MAHONING ROAD NE
 STA-0153-01.70

REVISIONS:
 CONSTRUCTION BIDDING SET
 APPENDIX NO. 1

REVISIONS	DATE	BY
CONSTRUCTION BIDDING SET	4/21/14	GEA
ADDENDUM NO. 1	5/7/14	GEA

INTERSECTION DETAILS
HILCHER AVE. NE / EAST VIEW AVE. NE

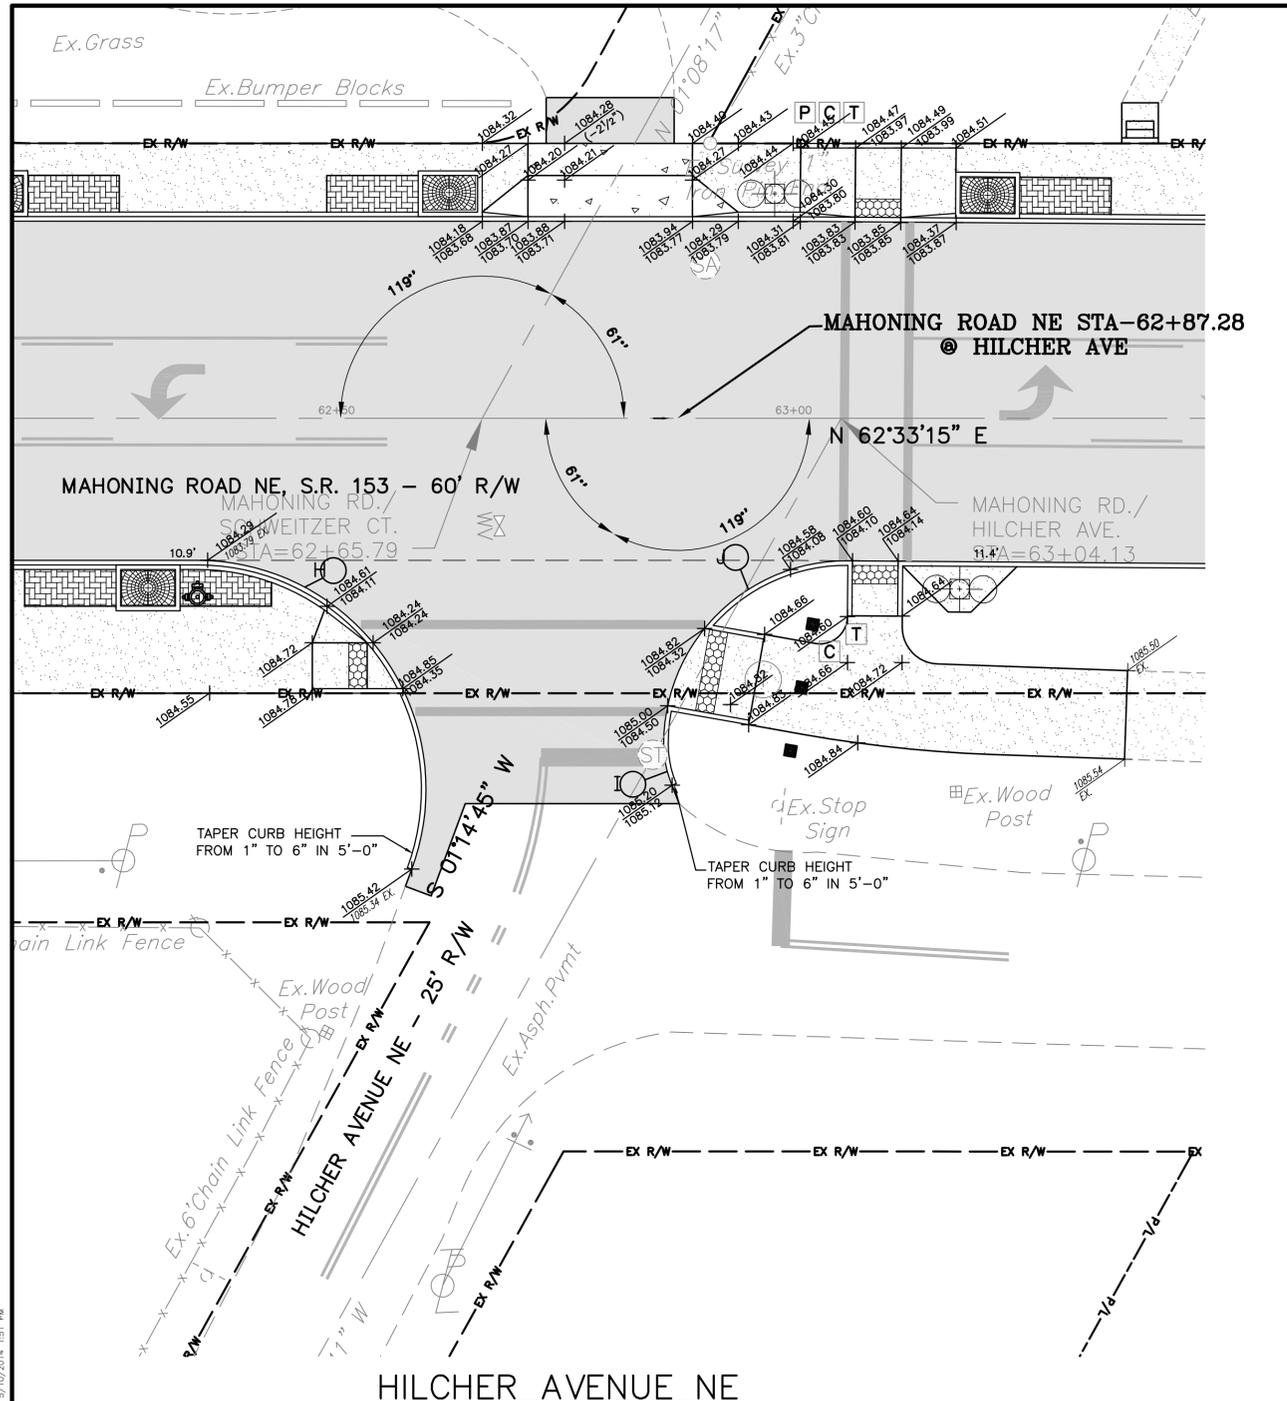
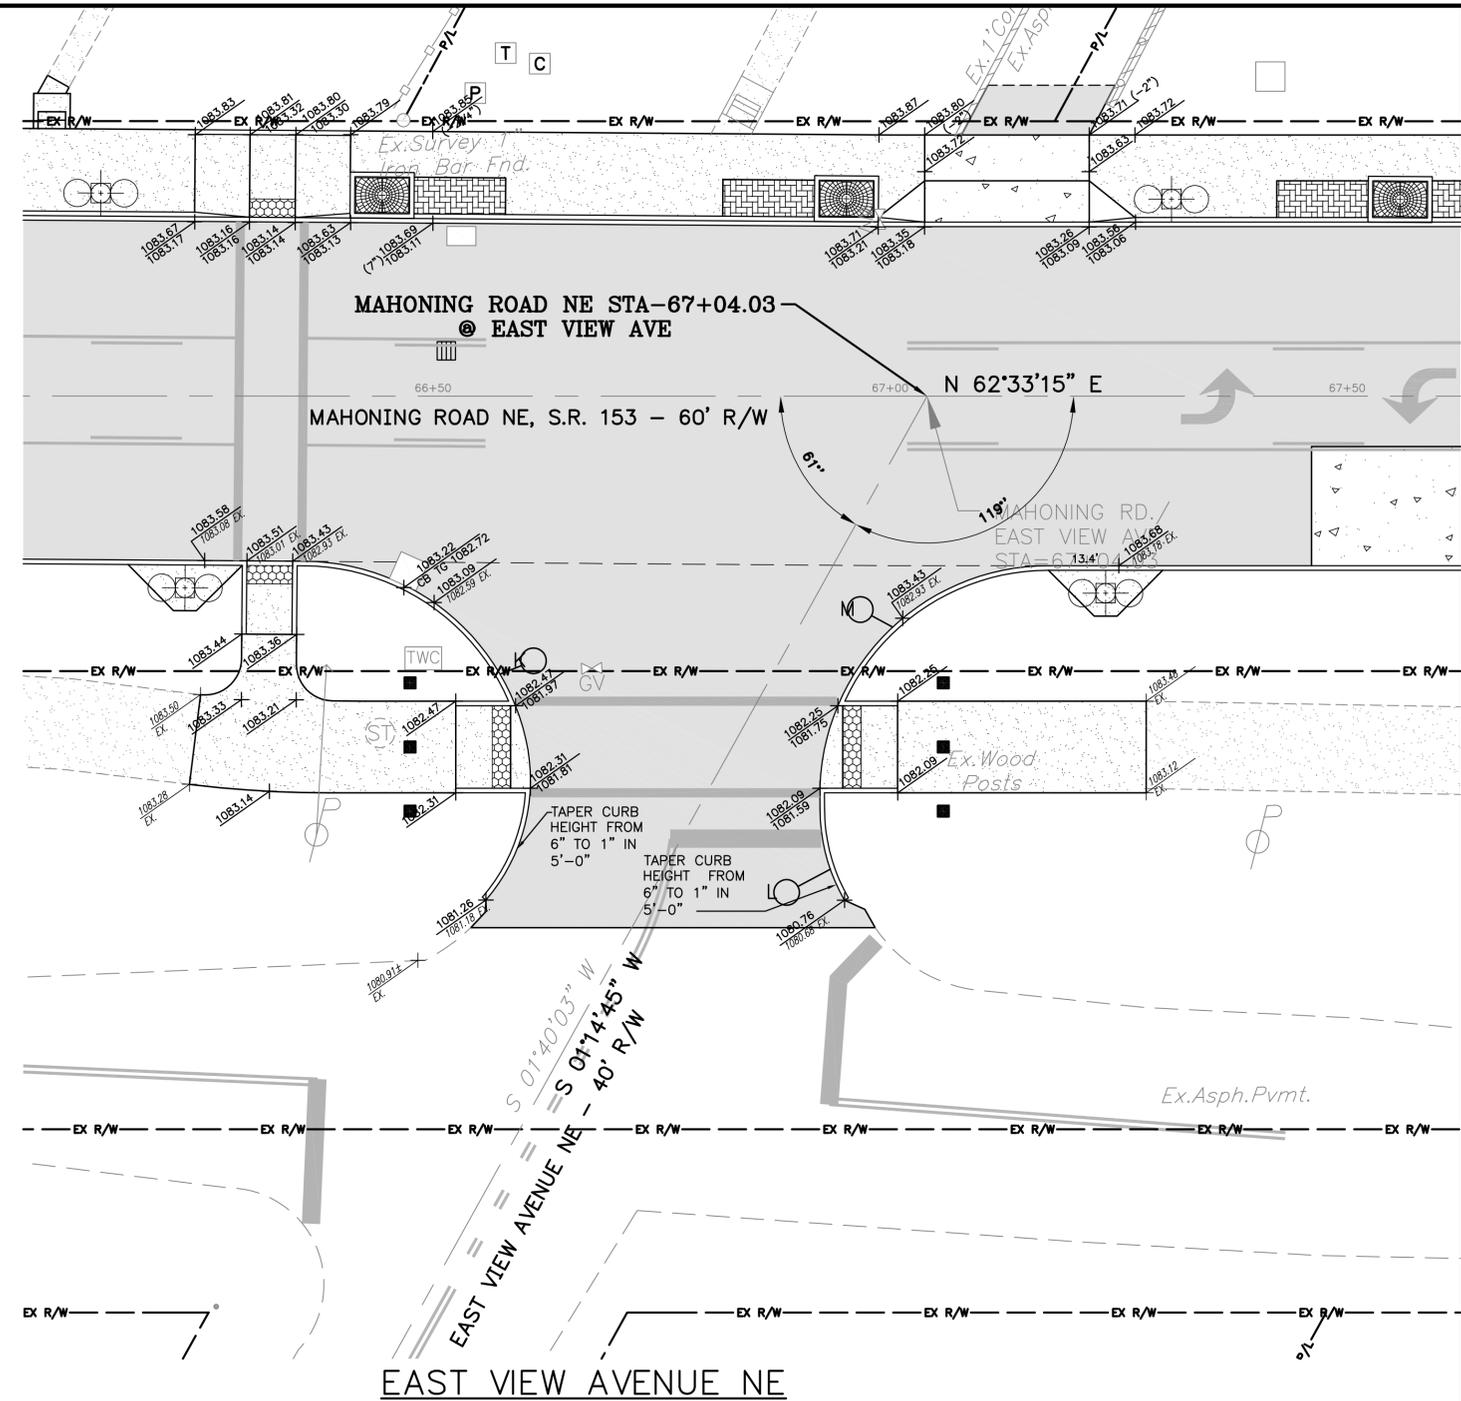
REVISIONS TO THIS SHEET INCLUDED:
 MINOR REVISIONS TO SPOT GRADES.

HARMONT AVENUE NE

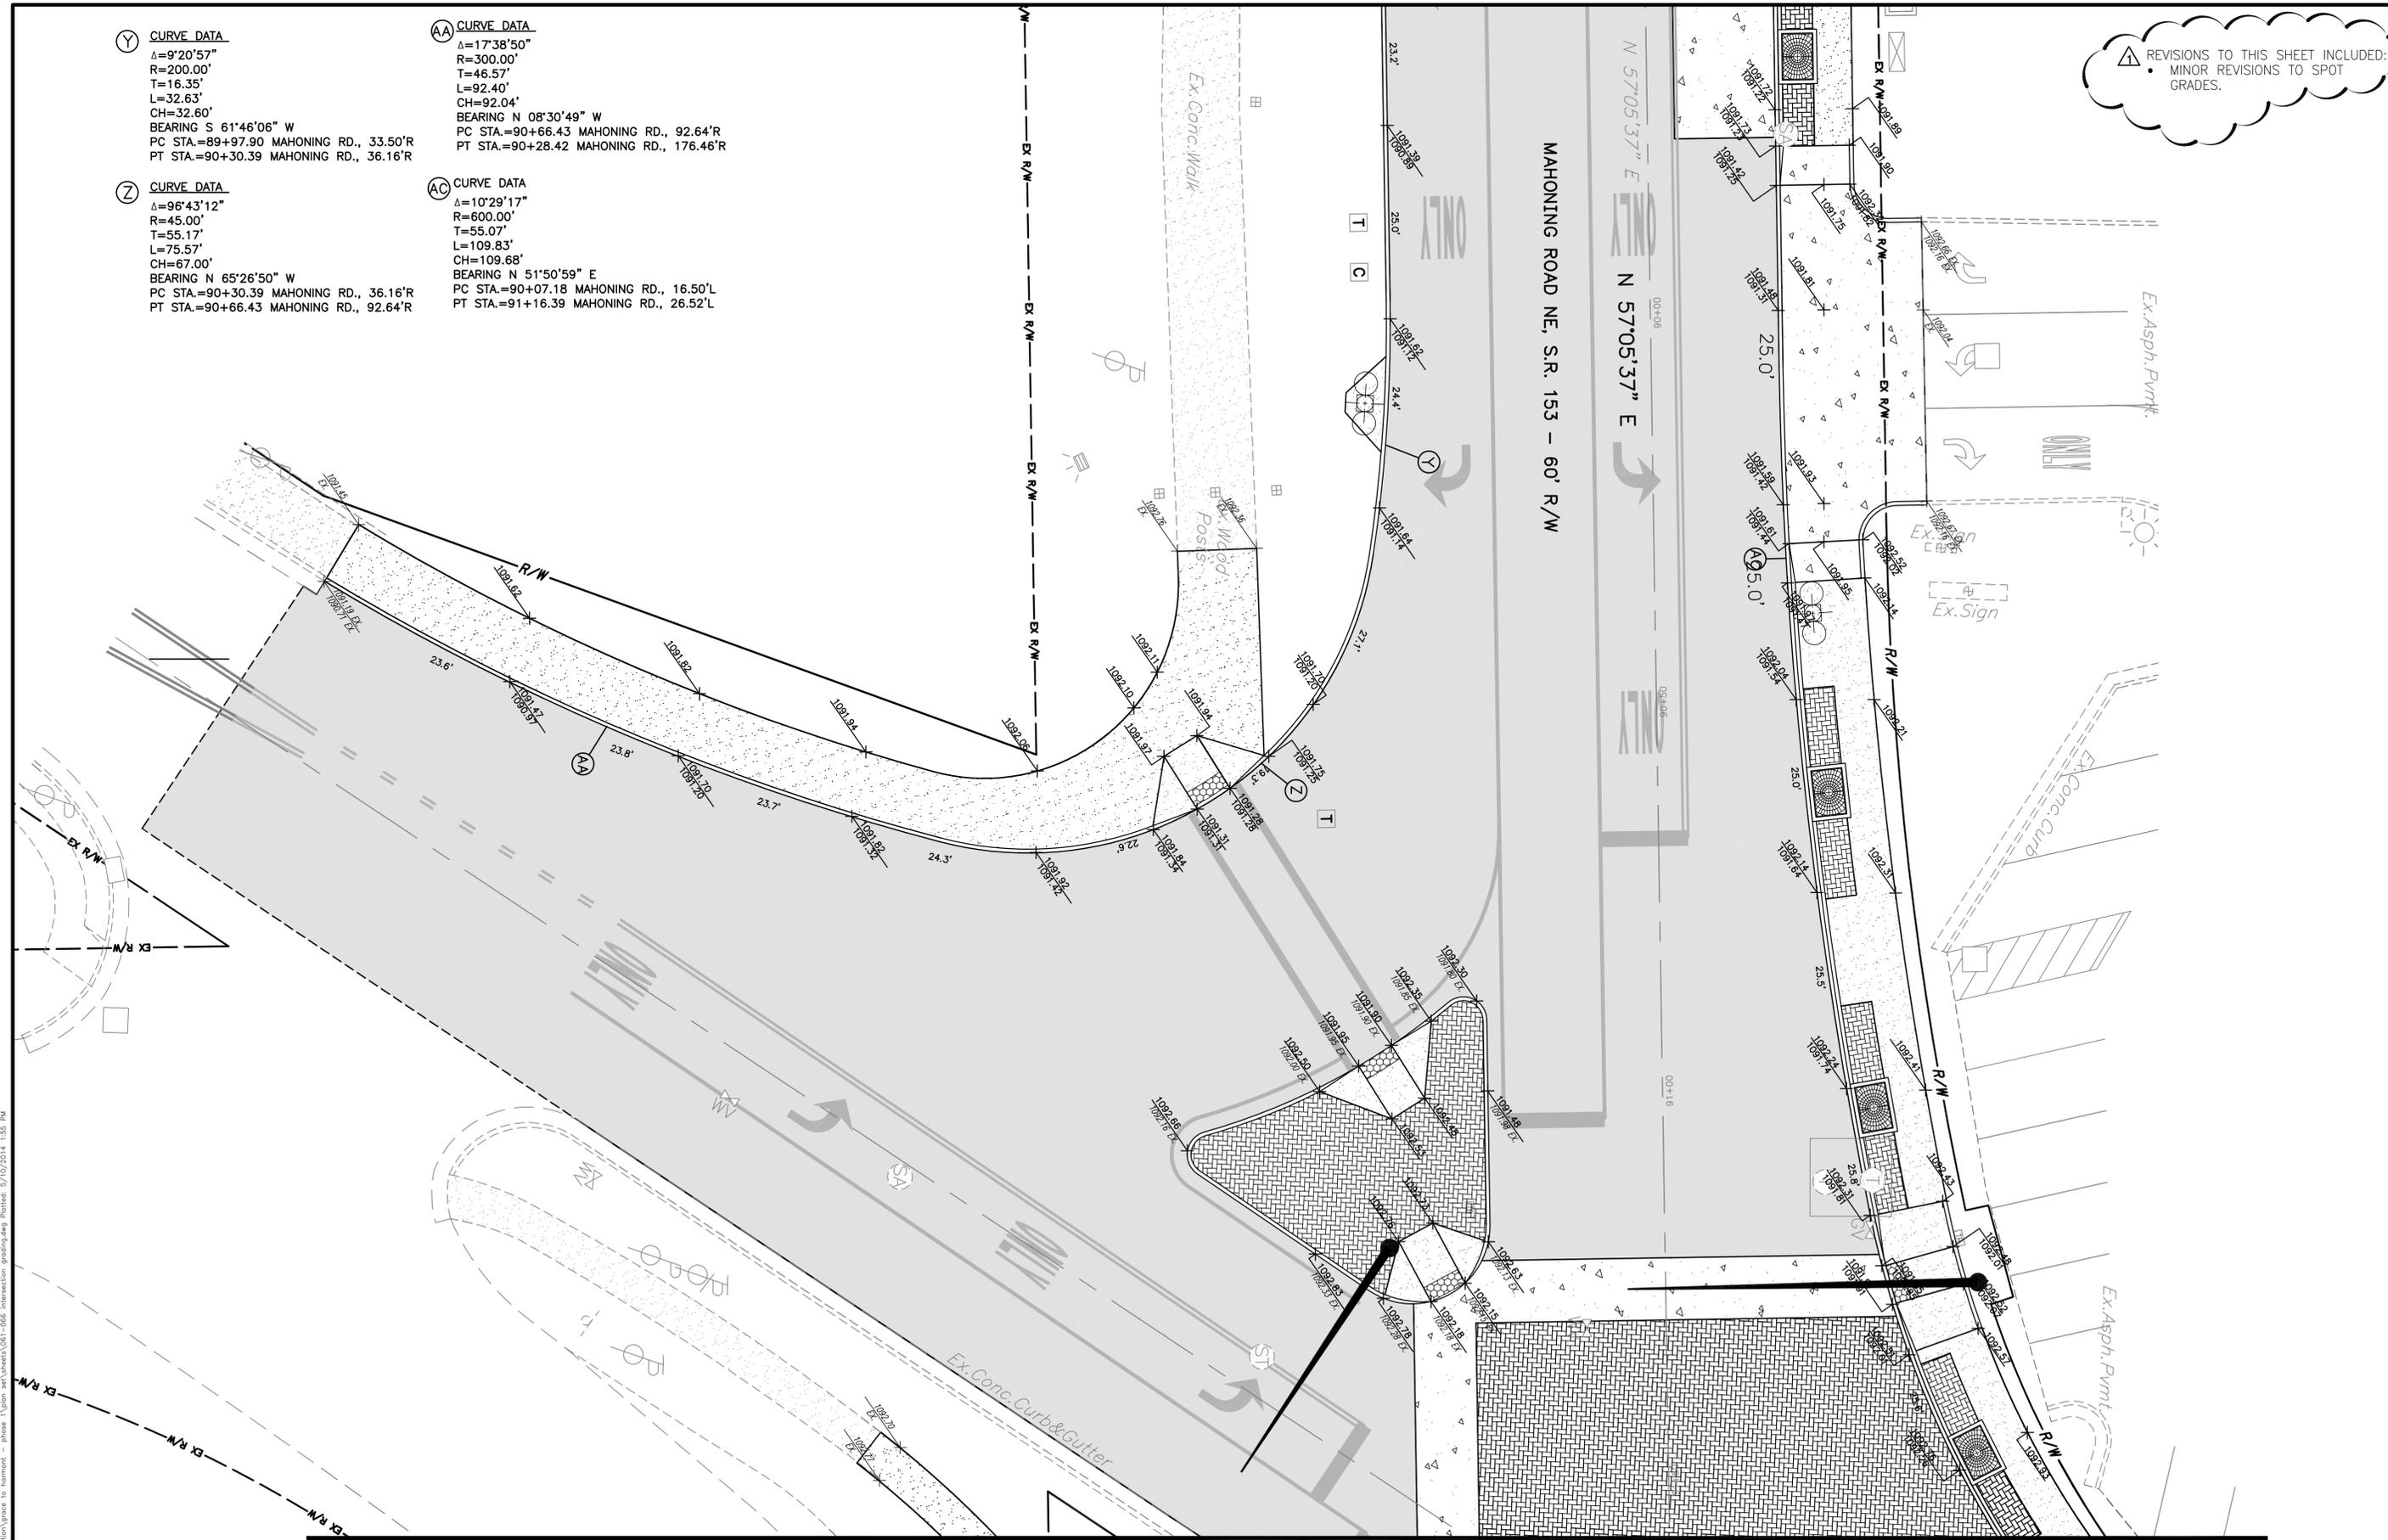
REVISIONS TO THIS SHEET INCLUDED:
 MINOR REVISIONS TO SPOT GRADES.
